Proposal Request

PROPOSAL REQUEST 089

Green Roof Devices and High Roof Security Cameras

PROJECT: AWSOM
BENTONVILLE, AR

Contents:
Layout - Lighting - Roof 1/2

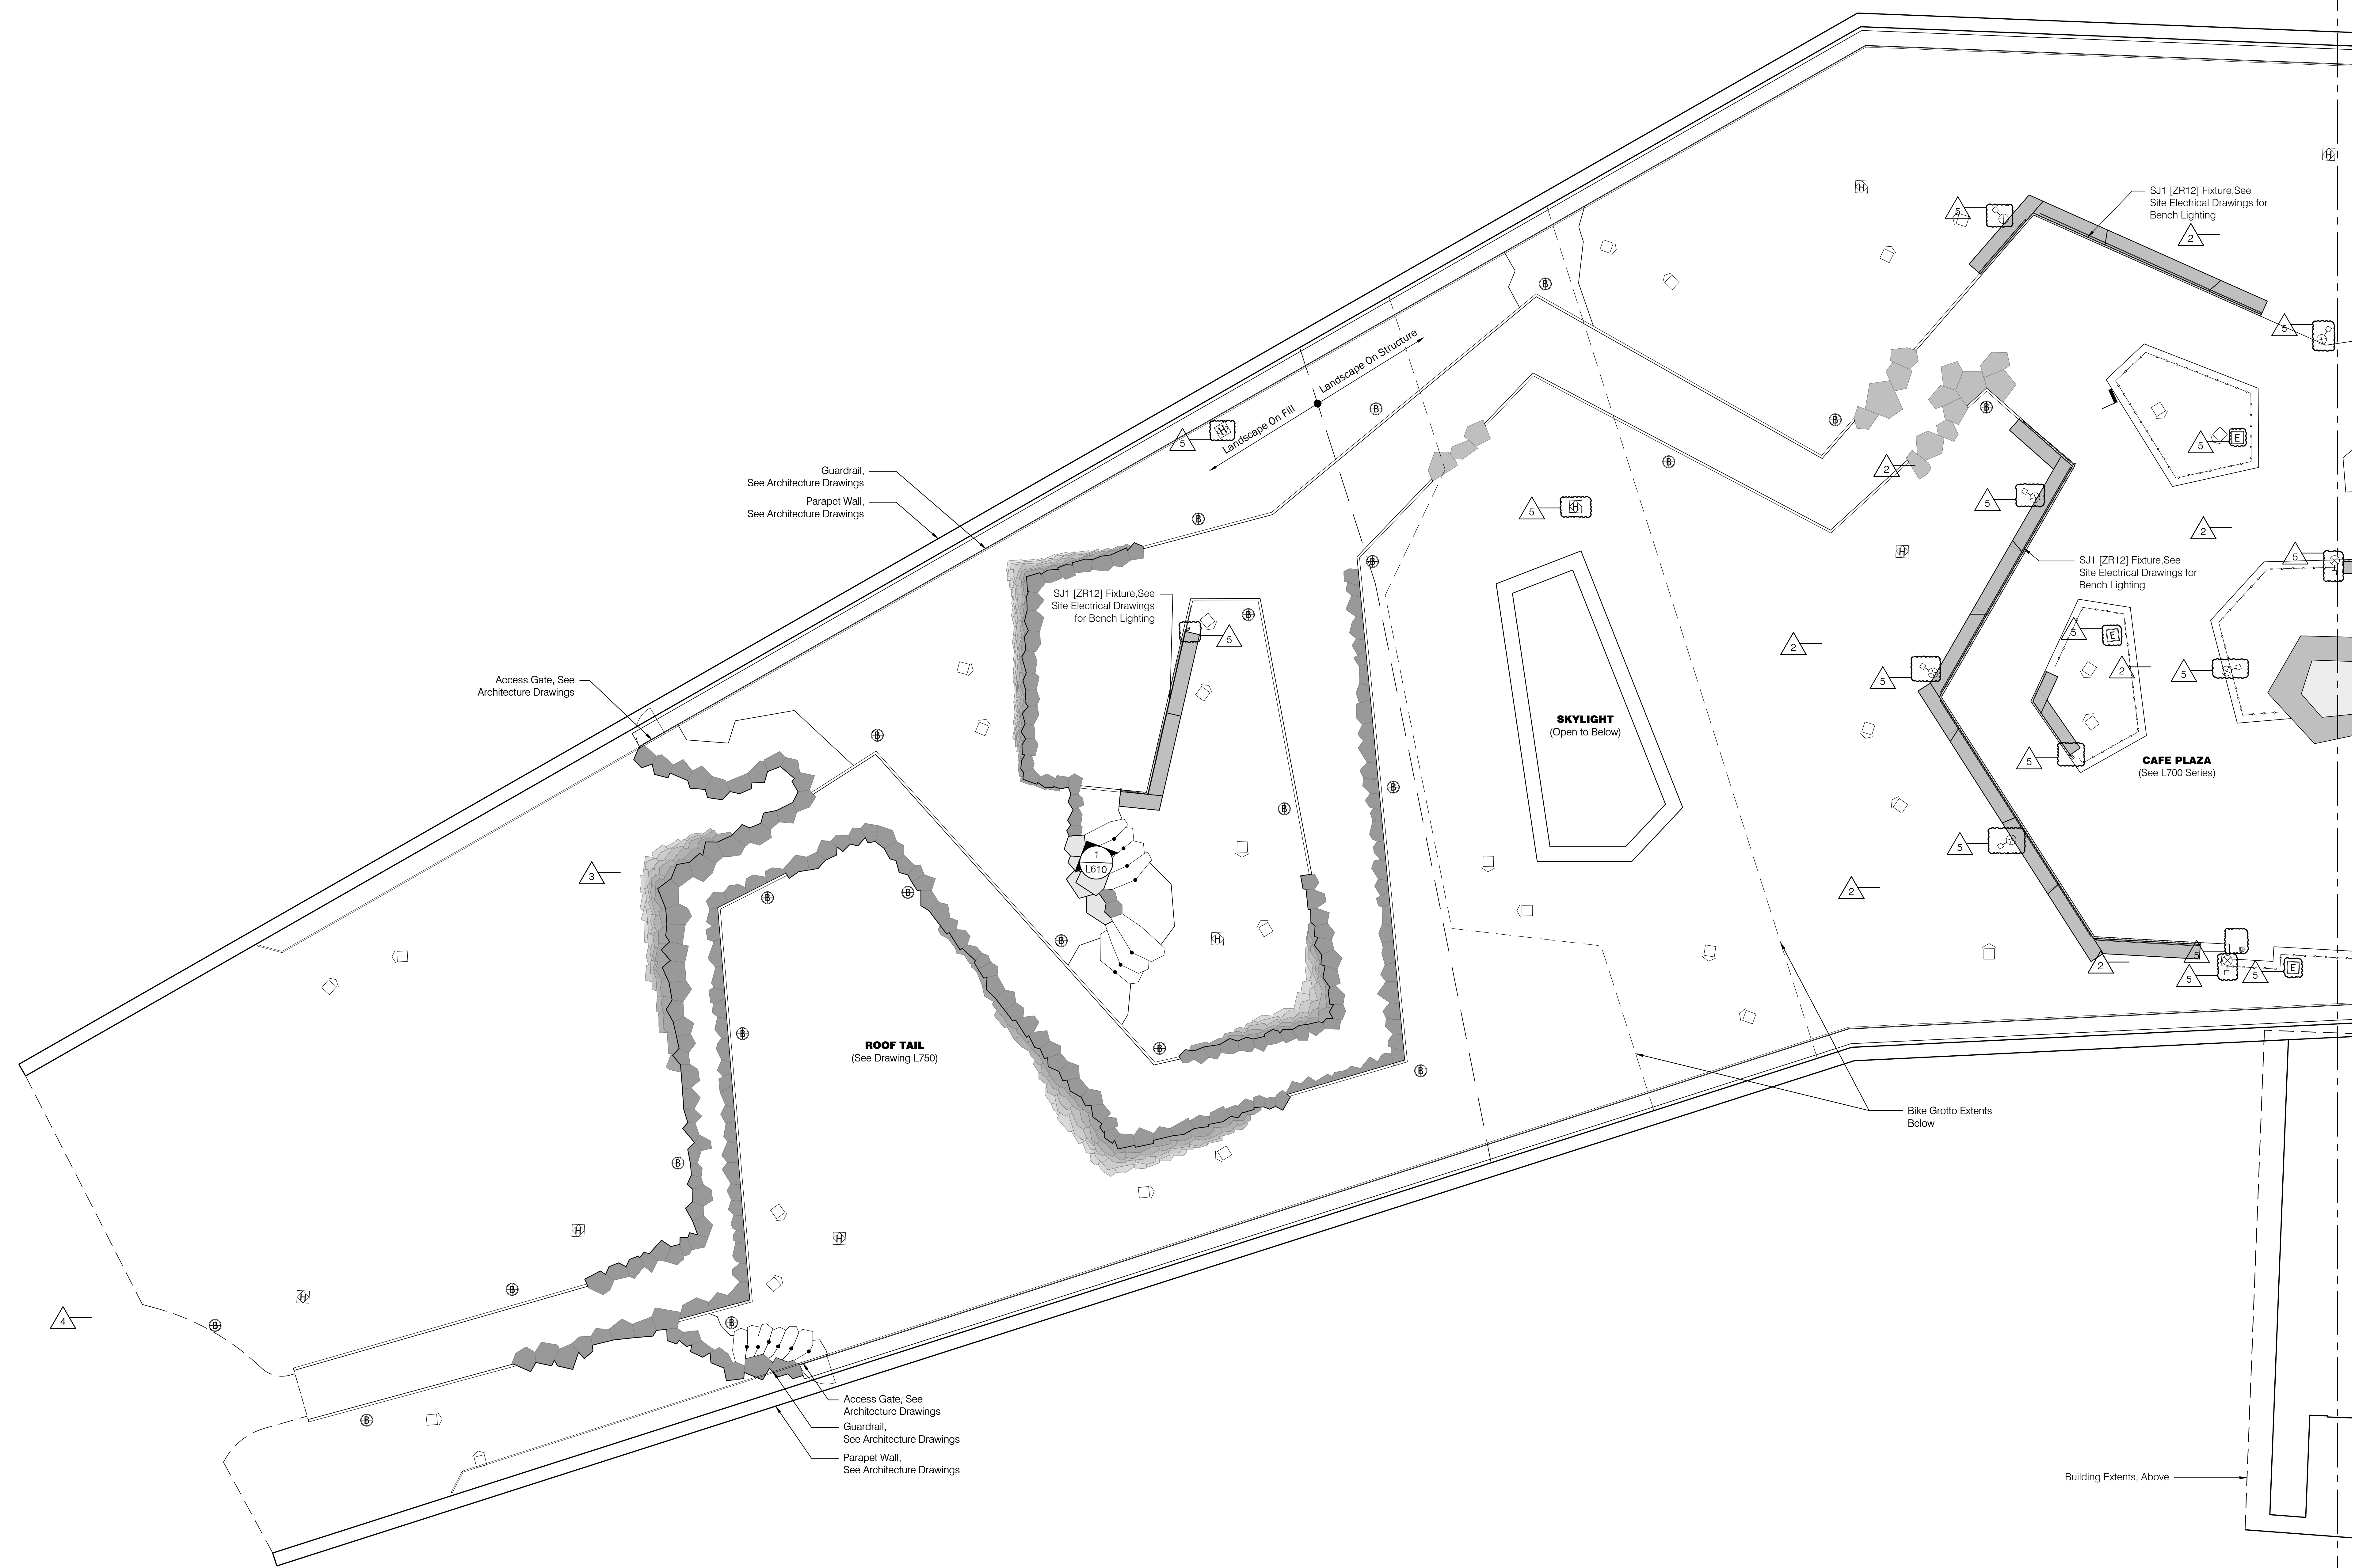
- a) Refer to Revised Sheet **L000B**, with original issue date 10.21.2024 and revised date 12.12.2024.
 - Updated sheet issuance for PR 089.
- b) Refer to Revised Sheet **L224**, with original issue date 03.13.2023 and revised date 12.12.2024.

- Revised Holiday Controlled Receptacle locations.
 - Revised Charging Pedestal locations.
 - Added Strobe on Post locations.
 - Added Exit Sign on Post locations.

- Added Light and Strobe on 16' Tall Pole locations.
 - Added Light, Exit Sign, and Strobe on 16' Tall Pole locations.
 - Updated Legend
- c) Refer to Revised Sheet **L225**, with original issue date 03.13.2023 and revised date 12.12.2024.

1 ELECTRICAL SITE PLAN - ROOF
 1/16" = 1'-0"

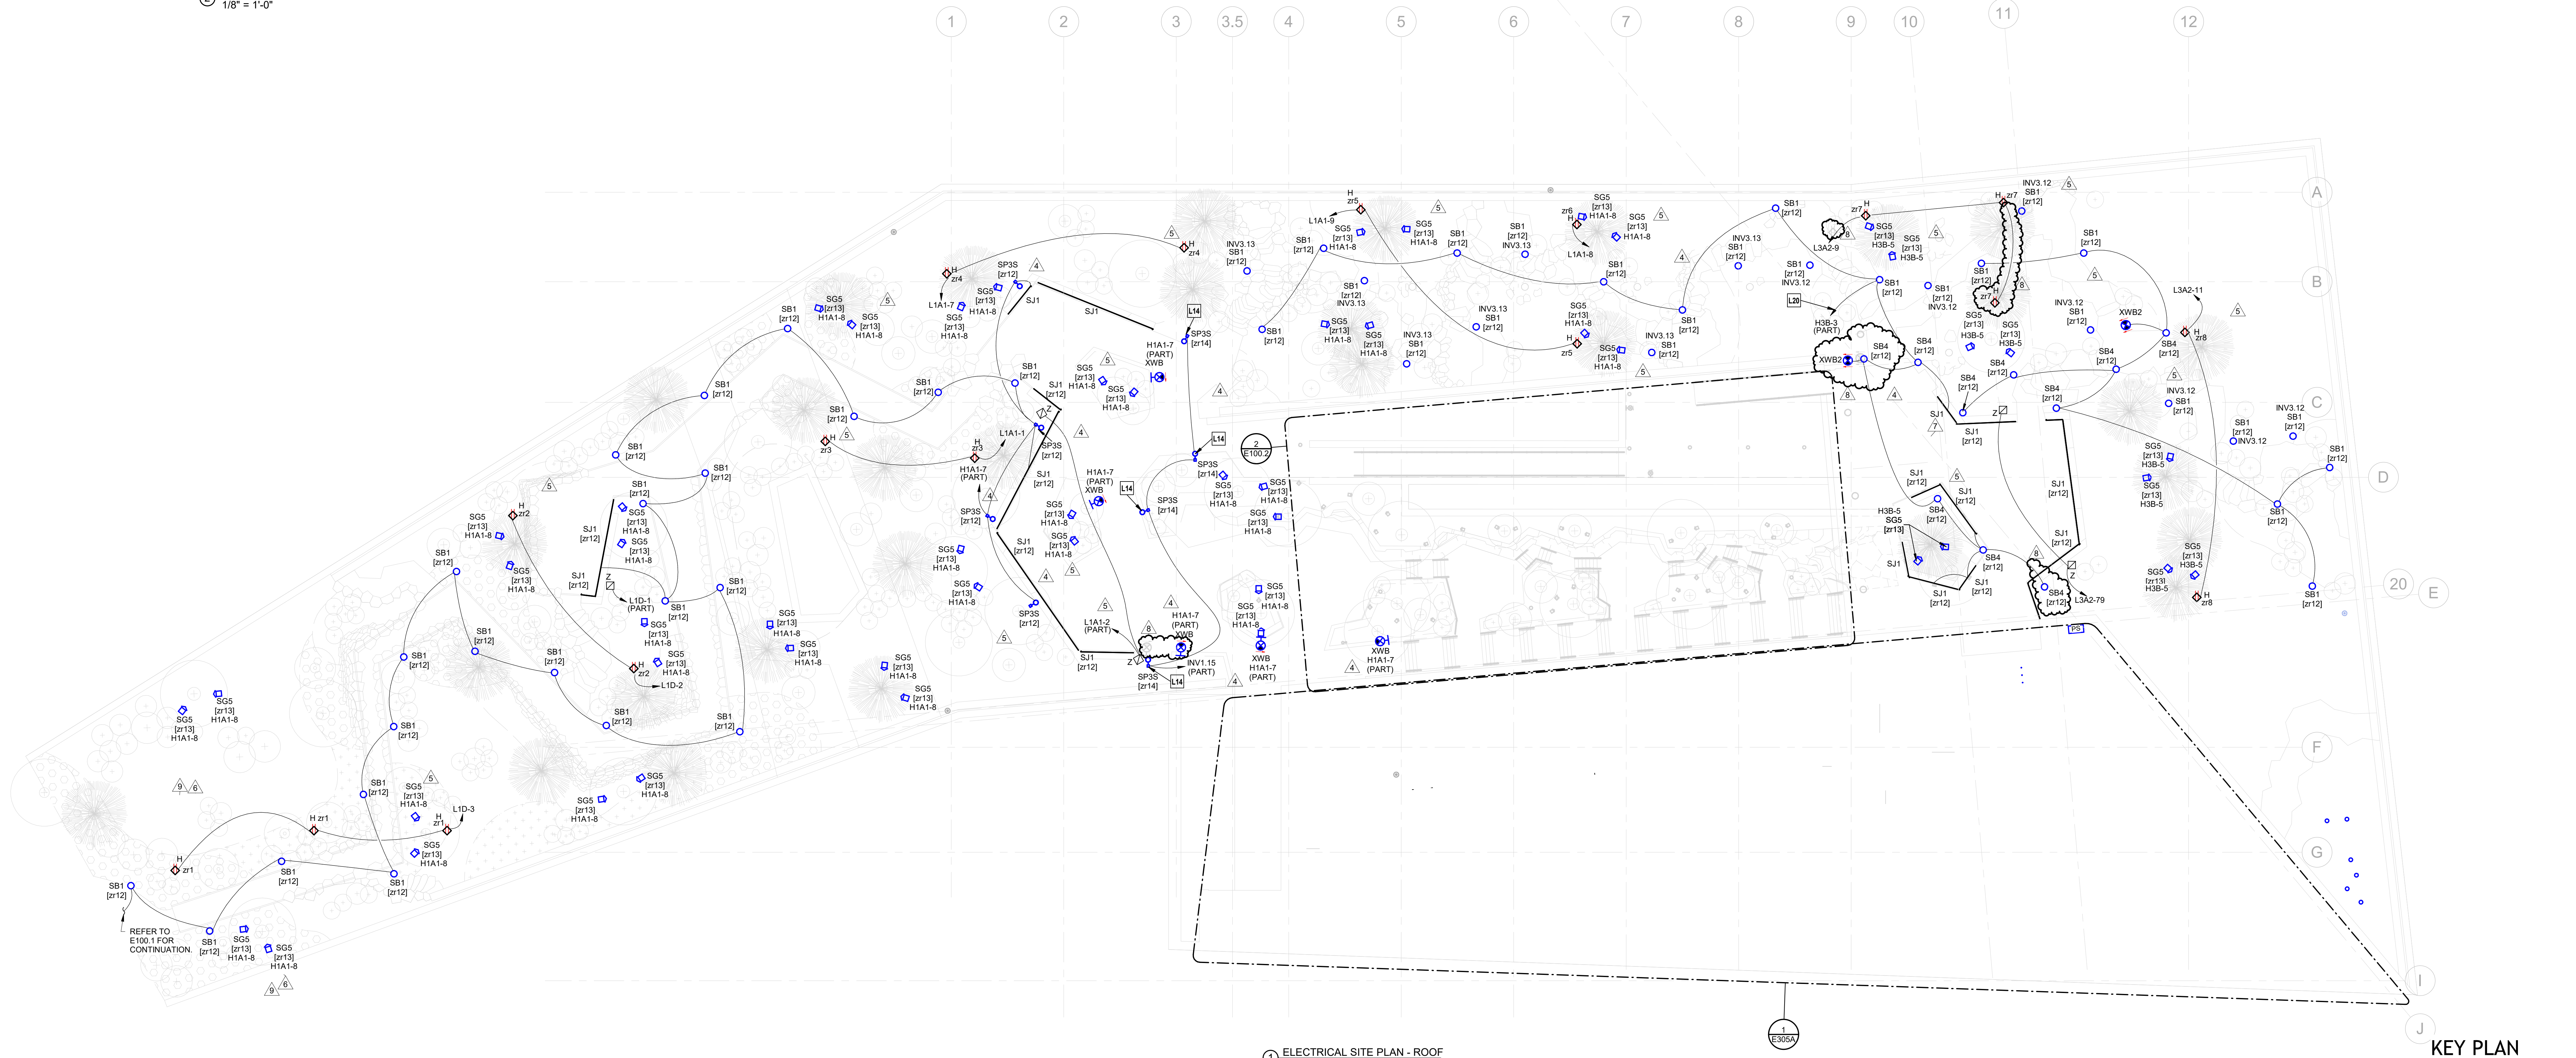
- a) General clarification: For all charging pedestals and precise dimensions for locations of devices, refer to landscape plans. The revisions indicated below are intended to identify significant location changes.
- b) Revised Sheet **E100.2**, Detail 1, with original issue date 02.24.2023 and revised date 12.12.2024.
 - To align with landscape coordination:
 - (1) Adjust location of two type SB4 light fixtures.
 - (2) Adjust location of one XWB2 fixture.
 - (3) Adjust location of one type H holiday receptacle pedestal.
- c) Revised Sheet **E100.2**, Detail 2, with original issue date 02.24.2023 and revised date 12.12.2024.
 - To align with landscape coordination and RFI 525:
 - (1) Remove exit sign on level 3 plaza.
 - (2) Adjust location of fixture SB4.

Consents:
TELECOM SITE PLAN - ROOF

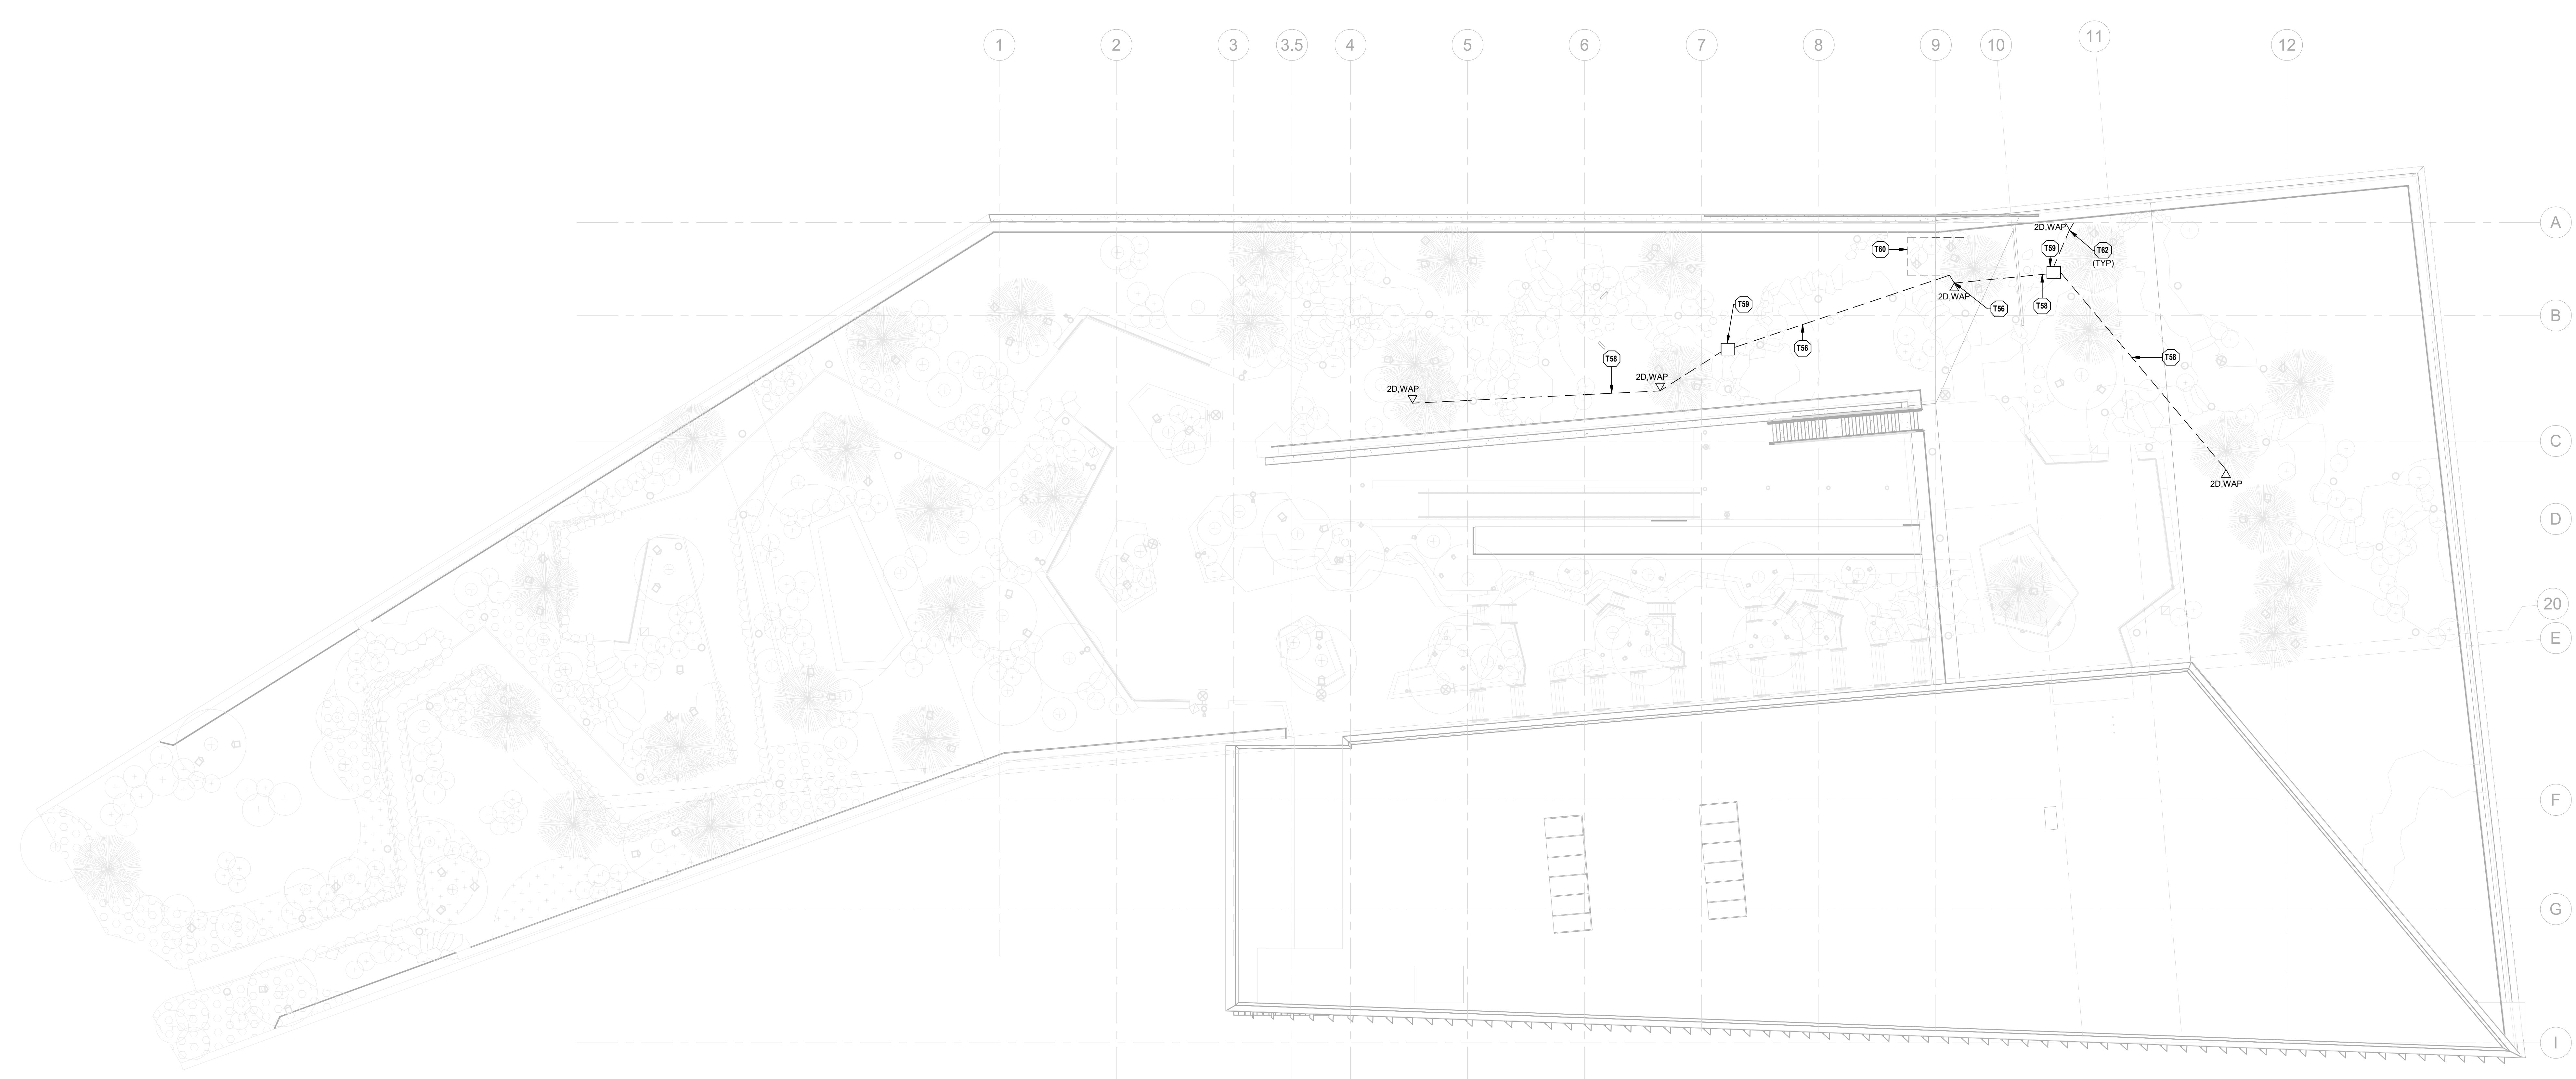
- a) Revised Sheet **TN000** with original issue date 02.24.2023 and revised date 12.12.2024.
 - Added note for wireless access points to legend.
- b) Added Sheet **TN100.2** with issue date 12.12.2024.
 - Added 5 wireless access point bollards to green roof.
 - Added conduit, pull box, and cabling for wireless access points.
- c) Revised Sheet **TN500** with original issue date 02.24.2023 and revised date 12.12.2024.
 - Added Exterior Wireless Access Point in Bollard detail.
